# CERTIFICATE OF APPROPRIATENESS

**HPO File#:** HP2025\_0243

**Property:** 1507 Ashland Street, 146, Houston Heights West

**Proposal:** Alteration:

NORTH ELEVATION-PROPOSED  
ESC 1/4" = 1'-0"

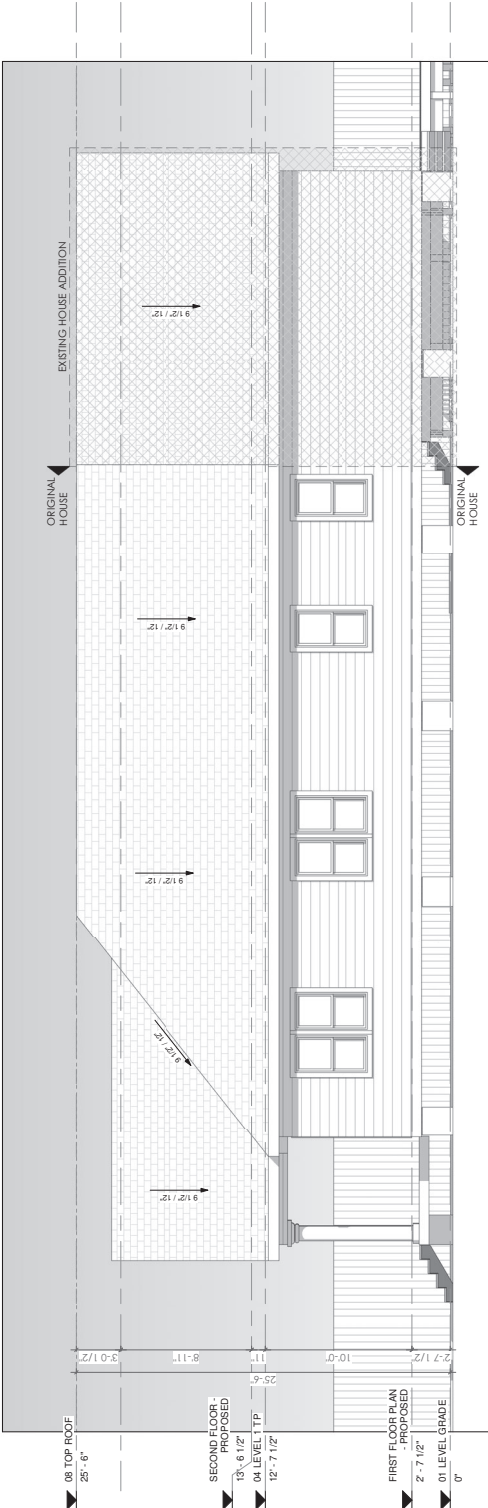
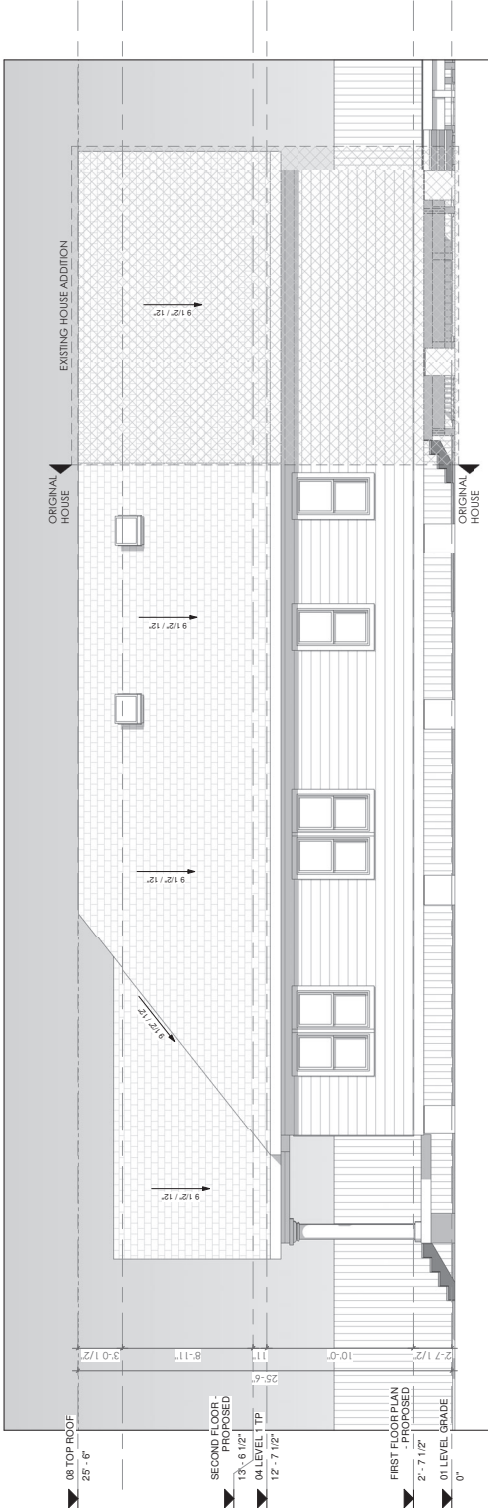
- Proposed gable-style new Dormer on existing North Elevation roof.
- Proposed dormer will match existing materials and maintain architectural consistency with the contributing structure, per Houston Heights guidelines.
- **Proposed wood window 1-over-1, single-hung** (Marvin brand, Ultimate Signature), 36 in. wide x 60 in. tall, inset and recessed, to meet **Historic Window Standards** (see below and attached diagram).

**PROPOSED WINDOW MUST BE INSET Minimum Depth of 1 ¾ inches from**

Exterior Casing to the Face of the Window Unit (Upper Sash).

Window must be equally **Horizontally Divided** if single or double-hung.
